RE: Urban Lot Split-Preliminary Parcel Map No.:
ADM-2023-7056-PMUL-HCA
Address: 2031-2033 North McPherson Avenue
Community Plan: Northeast Los Angeles
Zone: R1-1
Council District: 14 – Jurado

LETTER OF COMPLIANCE – Ministerial Review of SB 9 Urban Lot Split

PRELIMINARY PARCEL MAP L.A. NO. ADM-2023-7056-PMUL

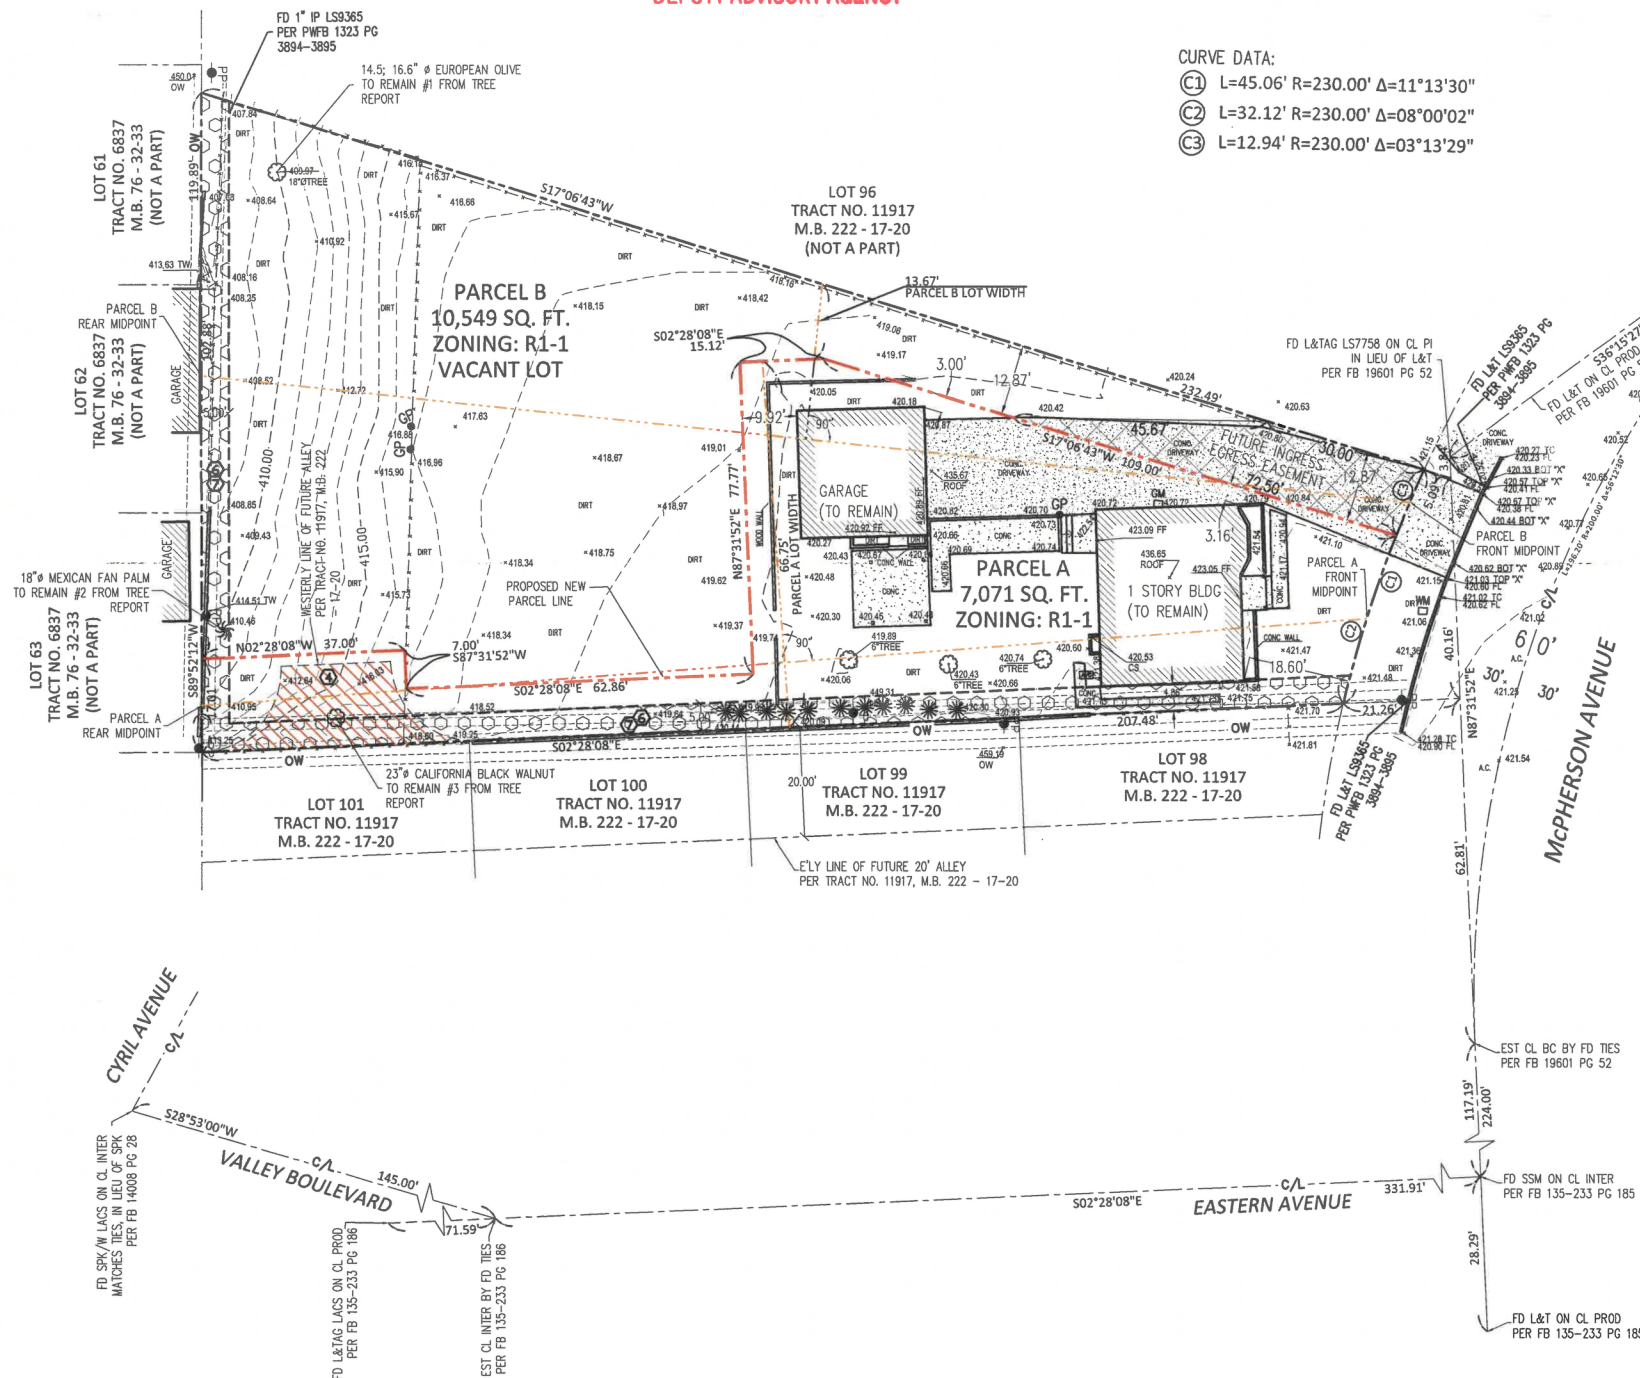
- c. Revise the Map to correct item # 5. This property is not located in a Hillside Area.
 - d. Provide building plans to show compliance with current Los Angeles City Residential Code concerning exterior wall/opening protection and exit requirements with respect to the new property lines.

- i. Provide 1-hr fire-resistance exterior walls if fire separation distance is: Less than 5' [T-R302.1(1)].
 - ii. Openings are not allowed within 3' fire separation distance. [T-R302.1(1) & T-R302.1(2)]

- iii. Maximum 25% opening area is allowed when the fire separation distance is between 3' and 5' for building without automatic sprinkler. (T-302.1(1)).

- e. If the proposed common driveway ingress and egress for the proposed Parcels A and B is less than 20 feet in width, obtain approval from the Advisory Agency to approve the deviations from the Zoning Code. A recorded covenant agreement for the common driveway ingress and egress shall be required.

- i. The proposed Parcel B does not provide the minimum required 20 feet street frontage to the public or private street and the minimum required 20 feet access strip width as required by the definition of a "lot".

- ii. The proposed Parcels do not provide the minimum required 50 feet of lot width for the R1 Zone per LAMC Section 12.08.C.4.
 - iii. One required parking space is required to remain for each remaining dwelling on the site. Show location of all parking spaces and access driveways or obtain approval from the Advisory Agency to approve the deviations from the Zoning code. Provide copies of permits and final inspection cards, for any new garages or carports.

- iv. Required driveway access for the proposed Parcel A is not within its own lot. Obtain Use of Land permits to relocate driveways and all required parking for each building onto their corresponding sites or obtain approval from the Advisory Agency to approve the deviations from the Zoning code. Provide a copy of permits and signed inspection cards to show work has been completed.

1. The street frontage and access strip of proposed Parcel B will have a street frontage of approximately 12.87 feet, in lieu of the 20-foot street frontage required per LAMC Section 12.03.
2. The lot width of proposed Parcel B is 13.67 feet, which is less than the 50 feet required per LAMC Section 12.08 C.4.
3. The access driveway for Parcel A will have a portion located on Parcel B instead of within its own lot as required per LAMC 12.21 A.4.(h).
- k. The Applicant shall sign an affidavit stating that the applicant intends to occupy one of the housing units as their principal residence for a minimum of three years from the date of the approval of the urban lot split.

Street Frontage and Access Strip Width. As conditioned by the Department of Building and Safety, Zoning Division and as required pursuant to LAMC Chapter 1, Section 12.03, a lot shall have a minimum 20-foot street frontage and a minimum 20 foot access strip width. Parcel A with the existing single-family dwelling provides the 20-foot access strip, however, Parcel B will only have a street frontage of approximately 12.87 feet as a result of the existing single-family dwelling built on Parcel A. As such, Parcel B is not required to conform to the street frontage and access strip width of LAMC 12.03 based on GCS 66411.7(i), which states that the City shall not require the correction of nonconforming zoning conditions as a condition for ministerial approval of a parcel map application for an urban lot split.

Lot Width. As conditioned herein by the Department of Building and Safety, Zoning Division and as required pursuant to LAMC Chapter 1, Section 12.03 and Section 12.08 C.4, a lot in the R1 Zone shall provide a minimum width of 50 feet as measured from the depth at the midpoint between the front and rear lot lines. The subdivision of the existing lot results in Parcel A being compliant with the lot width requirement with 66.75 feet while Parcel B will observe a lot width of approximately 13.67 feet. As such, Parcel B is not required to conform to the lot width requirement of 12.08 C.4 based on GCS 66411.7(i), which states that the City shall not require the correction of nonconforming conditions as a condition for ministerial approval of a parcel map application for an urban lot split.

Access Driveways. LAMC Section 12.21 A.4.(h) requires the access driveway to be located entirely on the lot which it serves. There is an existing dwelling on Parcel A and due to its existing configuration, Parcels A and B share a common access driveway. A portion of the access driveway for Parcel A is located on Parcel B. As such, Parcel A shall not be subject to the access driveway required by LAMC 12.21 A.4.(h) based on GCS 66411.7(i), which states that the City shall not require the correction of nonconforming conditions as a condition for ministerial approval of a parcel map application for an urban lot split.
